RE: Ramsey Homes – Public Alley Elevation Revisions

RAMSEY HOMES

ELEVATIONS

ALEXANDRIA, VA
CERTIFICATE OF APPROPRIATENESS
02.26.2018

A3

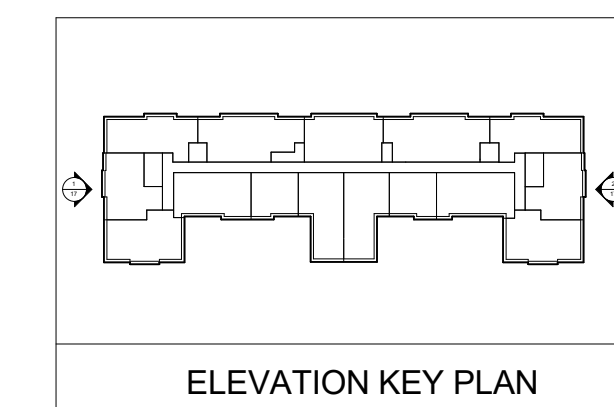
The BAR staff also suggested increasing the parapet height at the North and South shoulders of the building slightly in order to emphasize an articulation that is distinguished from the abutting brick façade with masonry banding. This revision is very subtle at 1'- 1 ½", but makes a significant improvement in this detailing.

WYTHE STREET - PROPOSED

PENDLETON STREET - PROPOSED

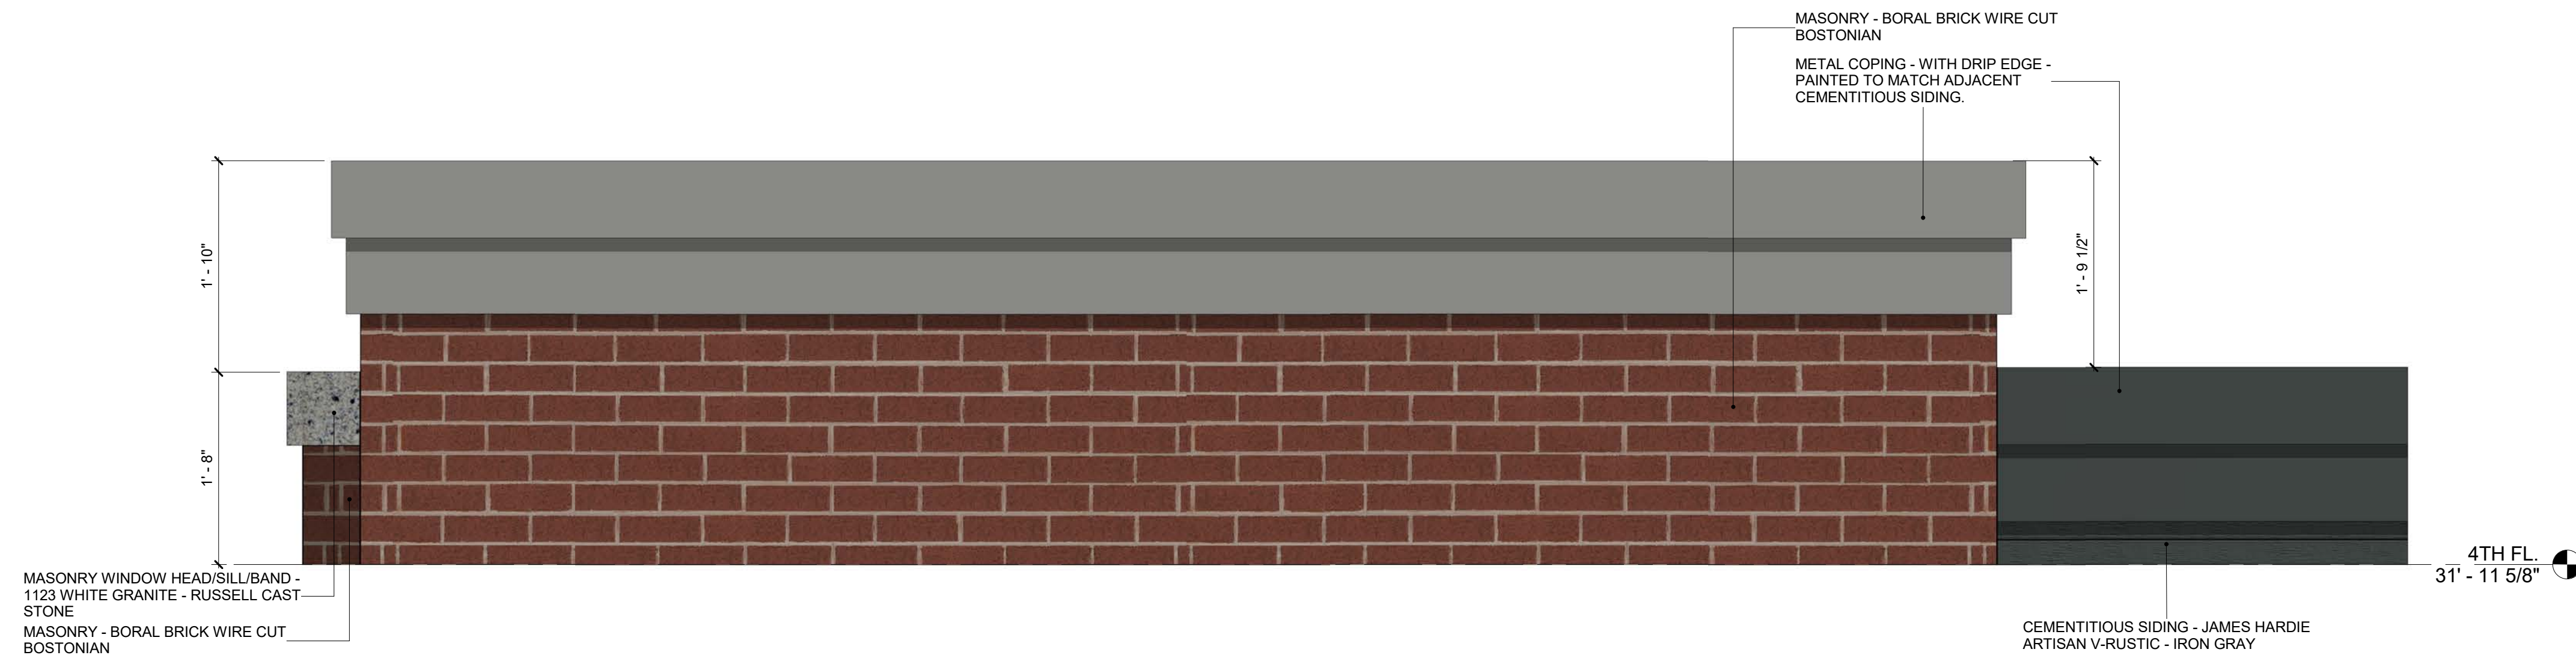
In addition to the above changes, decorative light sconces were required on the rear facade as a result of the photometric study provided in the approved Site Plan submission. These sconces were incorporated into the design as strategically as possible. For example, lights were centered between window stacks, or placed symmetrically to frame the garage entry. A specification of the selected light is included in this submission.

SYMMETRICAL PLACEMENT OF LIGHTING

SYMMETRICAL PLACEMENT OF LIGHTING
